Product change notification (PCN)

Title / short description	Design modification of M12 THR contact carriers (2-, 3-, 4- and 5-pin)
Affected article category	Connector
Change category	Form and appearance
Change number	CAF260011-00
Reason for PCN/PDN Revision

CAF260011

OLD	NEW

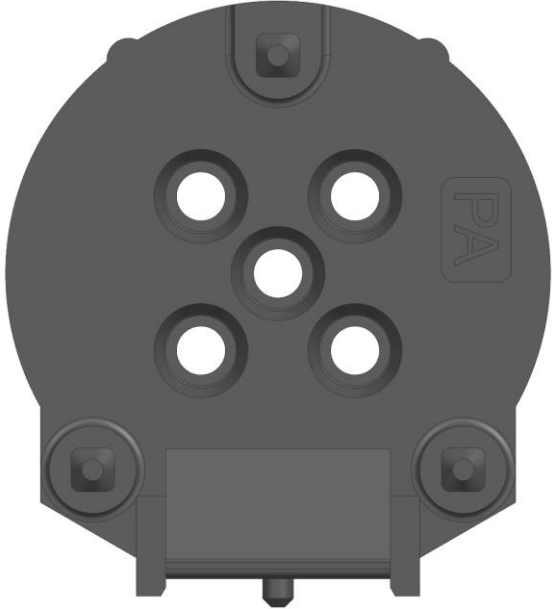
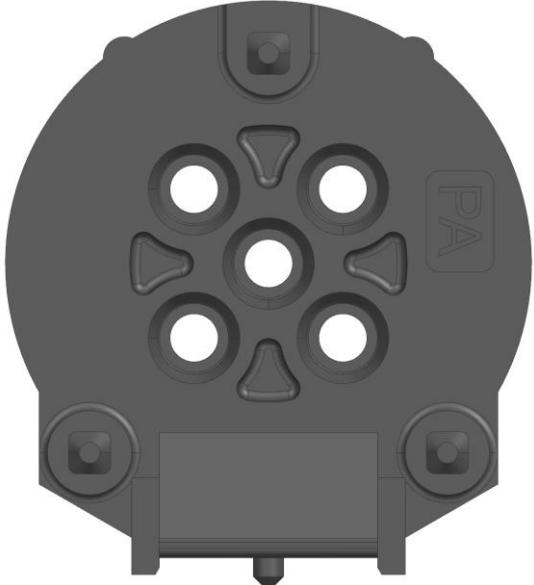
Design modification implemented to improve manufacturability

As part of our continuous improvement process, the design of the M12 THR contact carriers in 2-, 3-, 4-, and 5-position variants is being modified to improve manufacturability. The changes will be implemented starting in early Q1 2027. Due to existing inventory, an extended transition period may occur. This change applies to the listed part numbers. Please refer to the attached presentation for detailed information regarding the design modifications. This is a design change only; mechanical and electrical properties, as well as form, fit, and function, remain unchanged.
